HIGHCREST SUBDIVISION UNIT ONE

RESUBDIVISION OF LOT 63

APPLICATION NUMBER 24 DATE January 3, 2008

DETAIL SITE PLAN

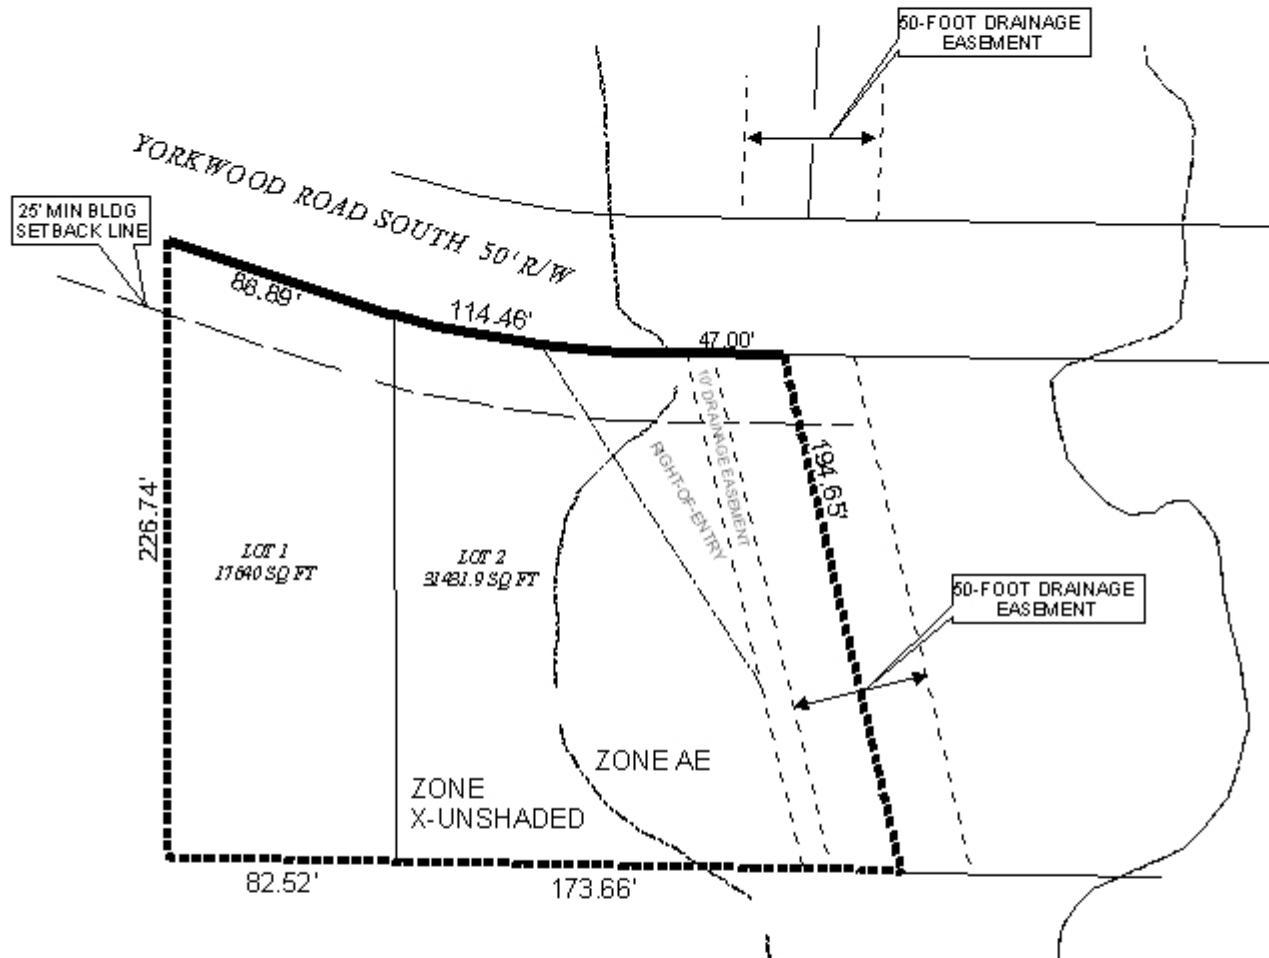
Engineering Comments: No fill in AE or x-shaded flood zones without flood study. Check location of drainage easement; it does not match up with riprap shown. Engineering department approval required on drainage easement before final plat is signed. It is the responsibility of the applicant to look up the site in the City of Mobile (COM) GIS system and verify if NWI wetlands are depicted on the site. If the COM GIS shows wetlands on the site, it is the responsibility of the applicant to confirm or deny the existence of wetlands on-site. If wetlands are present, they should be depicted on plans and/or plat, and no work/disturbance can be performed without a permit from the Corps of Engineers. Must comply with all storm water and flood control ordinances. Any work performed in the right of way will require a right of way permit.

As indicated on the plat, a portion of the site is located in the flood plain for Spring Creek; therefore, the approval of all applicable federal, state and local agencies would be required prior

to the issuance of any permits or land disturbance activities. The plat also illustrates 35' of a 50' drainage easement and all of a right-of-entry easement on the Eastern part of Lot 2. A note should be placed on the final plat stating that no permanent structure shall be constructed within these easements. Furthermore, according to the applicant, the right-of-entry is contained in the deed for the drainage easement, so as to provide access. It is recommended that the applicant submit documentation clarification this right-of-entry prior to signing the final plat.

1. placement of a note on the final plat stating that each lot is limited to one curb cut to Yorkwood Road South, with the size, location, and design to be approved by Traffic Engineering and conform to AASHTO standards;

2. the applicant obtain any necessary federal, state, and local environmental approvals prior to the issuance of any permits;
3. placement of a note stating that no permanent structure shall be constructed within the right-of-entry nor drainage easements;

4. the applicant provide documentation clarifying the right-of-entry prior to signing the final plat; and
5. subject to Engineering comments: *(No fill in AE or x-shaded flood zones without flood study. Check location of drainage easement; it does not match up with riprap shown. Engineering department approval required on drainage easement before final plat is signed. It is the responsibility of the applicant to look up the site in the City of Mobile (COM) GIS system and verify if NWI wetlands are depicted on the site. If the COM GIS shows wetlands on the site, it is the responsibility of the applicant to confirm or deny the existence of wetlands on-site. If wetlands are present, they should be depicted on plans and/or plat, and no work/disturbance can be performed without a permit from the Corps of Engineers. Must comply with all storm water and flood control ordinances. Any work performed in the right of way will require a right of way permit.)*
